Responses to Reviewers

Response to Reviewer 1 Comments

Figure 3: Labeled physical prototype photo added in the revised Mechanical Structure subsection.

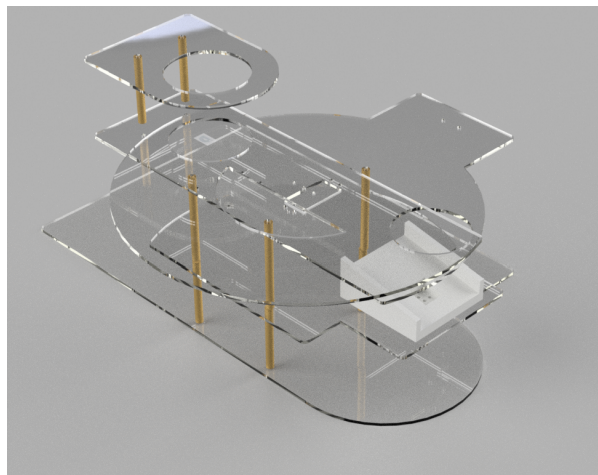
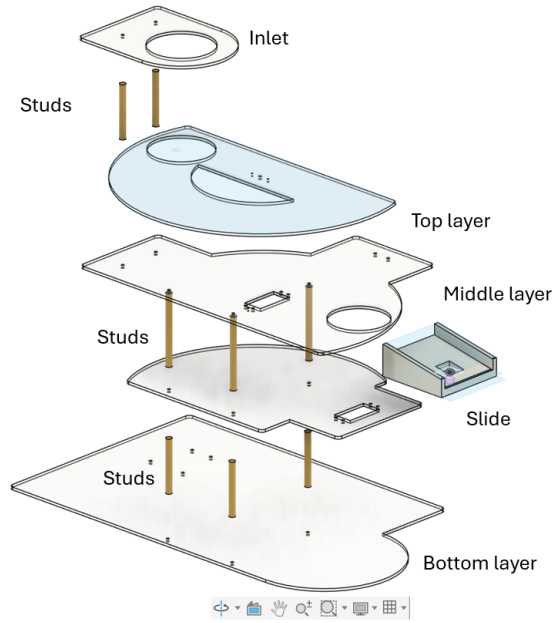
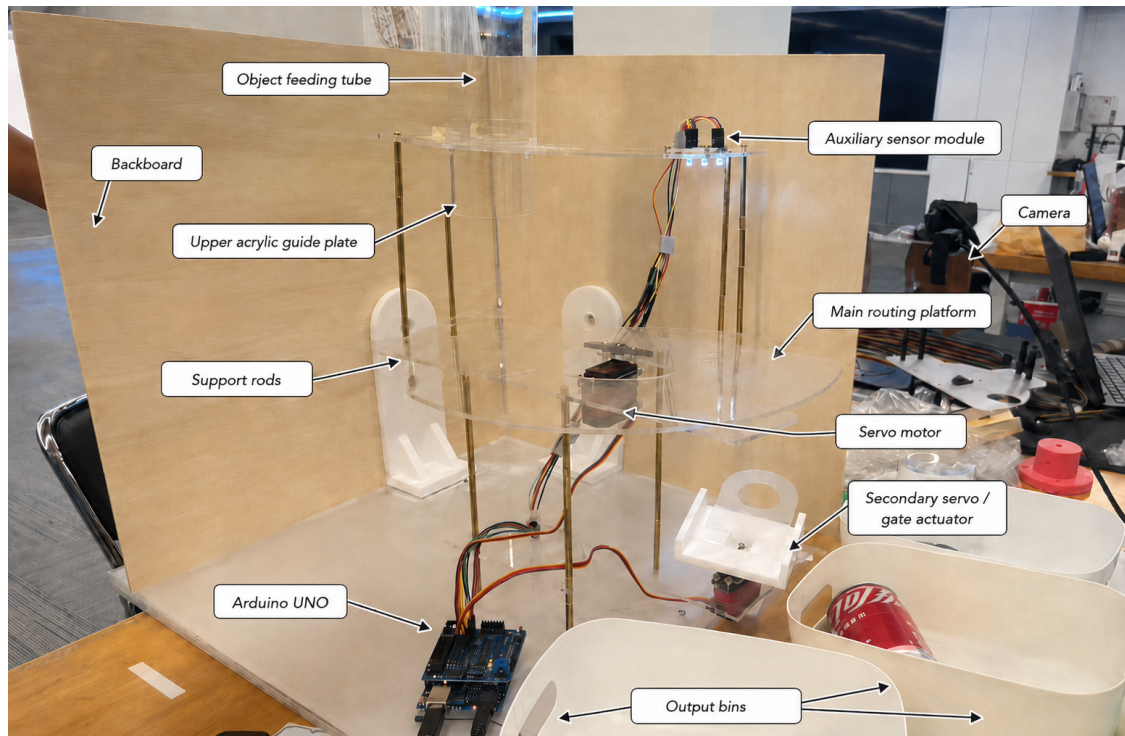
Comment 1: Add real photos and figures of the whole system. Label the components. Improve Figure 2 because it is too dark.

Response 1: We agree with the reviewer. The original Figure 2 was too dark and did not clearly show the physical layout of the prototype or the relationship among the main components. In the revised report, we improved the Mechanical Structure subsection by adding a clearer set of mechanical figures. The original dark figure was replaced and supplemented with three views: an assembled CAD rendering, an exploded mechanical structure view, and a labeled physical prototype photo. The assembled CAD rendering shows the overall geometry of the three-tier acrylic structure. The exploded view clarifies the layer-by-layer assembly, including the inlet, top layer, middle layer, bottom layer, slide, and support studs. The labeled prototype photo identifies the major components of the final system, including the object feeding tube, backboard, upper acrylic guide plate, support rods, auxiliary sensor module, camera, main routing platform, servo motor, secondary servo/gate actuator, Arduino UNO, and output bins. These revisions make the mechanical design easier to understand from the perspectives of assembled structure, structural decomposition, and physical implementation. The change can be found in Section 2.4.2, the Mechanical Structure figures.

[To improve the readability of the mechanical design, the Mechanical Structure subsection was revised with three complementary figures. The revised figures include an assembled CAD rendering of the three-tier mechanical structure, an exploded view showing the inlet, top layer, middle layer, bottom layer, slide, and support studs, and a labeled physical prototype photo. The physical prototype photo identifies the object feeding tube, backboard, upper acrylic guide plate, support rods, auxiliary sensor module, camera, main routing platform, servo motor, secondary servo/gate actuator, Arduino UNO, and output bins. Together, these figures more clearly show the overall mechanical layout, layer-by-layer assembly, and final fabricated implementation of the sorting system.]
